Water Assessments - Response to Submissions

Prepared for Holcim (Australia) Pty Ltd June 2022

This report provides a response to a submission from the NSW Environment Protection Authority (EPA) and a combined submission from the Department of Planning, Industry and Environment Water (DPIE Water) and the Natural Resources Access Regulator (NRAR) regarding the water aspects of the Environmental Impact Statement (EIS) prepared by EMM Consulting Pty Ltd for the Dubbo Quarry Continuation Project (the project). Holcim (Australia) Pty Ltd are the applicant for the project.

Dubbo Quarry Continuation Project

Figure 2.1 Eastern Watercourse: gravity diversion constraints

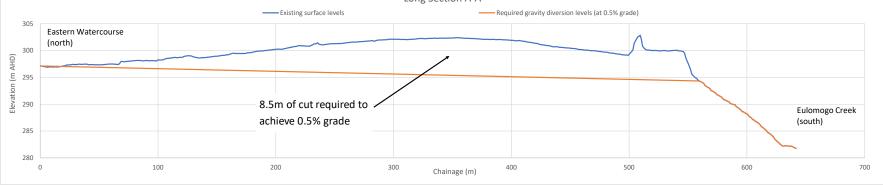
Issue ID	2.2
Raised by	EPA
Issue description	The EPA has noted that the EPL2212 does not permit any discharges from the site and that the existing conditions water balance predicts discharges from the Settling Pond to Eulomogo Creek.
	The EPA has also noted that the site is not permitted to discharge waters where there is likely to be or will be a change in the physical, chemical or biological indicators in the receiving water or where the discharge contains prescribed pollutants under the Protection of the Environment (Operations) General Regulation 2009 unless this is authorised by the Licence.

Response	Holcim acknowledges that the inflow of the Eastern Watercourse to the East Pit is inconsistent with best practice. However, this is a legacy issue of the site that relates to work that was undertaken under an existing approval, to which Holcim inherited. Diversion of the Eastern Watercourse around the East Pit is not considered feasible due to topography, biodiversity and landownership constraints, and proximity to the East Pit. These constraints are described in Figure 2.1. Therefore, Holcim has obtained a Water Access Licence (WAL) to account for the capture of runoff from the Eastern Watercourse in the East Pit. Refer to the Water Addendum for further information on these licencing arrangements.

Response	Holcim acknowledges that discharges from the current operations are not specifically permitted in EPL2212. However, it is noted that the discharge regime has been known to regulators for some time and that an objective of the project is to seek approval for discharges whilst reducing the likelihood of discharges occurring where possible.
	Historic discharges from the quarry have been predominantly driven by groundwater inflows from the palaeochannel into the East Pit, which is dewatered to allow for resource extraction. As described in the SWA (both V1 and V2) and in the Water Addendum, following completion of extraction from the East Pit (expected by end of 2022) it is proposed to allow the East Pit to fill to an equilibrium level, which will minimise future groundwater inflows and the associated need for discharge. This is the only practical way to stop or significantly reduce palaeochannel inflows into the quarry's water management system.

Figure 2.3 Conceptual model of East Pit

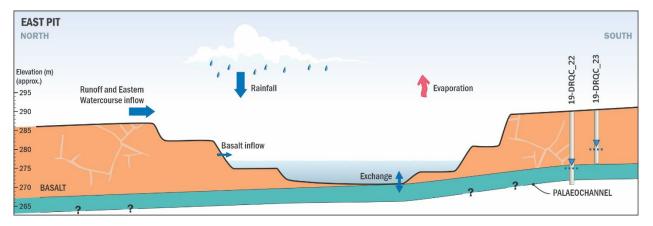
Issue ID	3.1
Raised by	DPIE Water and NRAR
Issue description	DPIE Water and NRAR have requested that a detailed conceptualisation of the hydrogeology of the quarry site, including cross-sections, be provided to better visualise the pit elevations and water table and to better understand the groundwater dynamics in the vicinity of the pit.
Response	The Water Addendum (see Appendix A Chapter 2) describes the hydrogeological conceptualisation which includes cross sections of the East Pit and proposed extension areas (refer Figures 2.3, 2.4 and 2.5 in the Water Addendum.

The conceptual understanding of the quarry's existing East Pit is depicted in Figure 2.3. Historic quarry activities within the East Pit inadvertently intercepted the underlying palaeochannel, which exists between 275 and 269 m AHD at this location. Anecdotal evidence indicates the intercepted palaeochannel is the predominant source of groundwater inflows to East Pit. Surrounding East Pit, the palaeochannel is somewhat depressurised due to ongoing dewatering activities. Temporary pit inflows from the basalt may occur where saturated fractures are intercepted; however, these fractures have low storage and are, therefore, quickly dewatered.
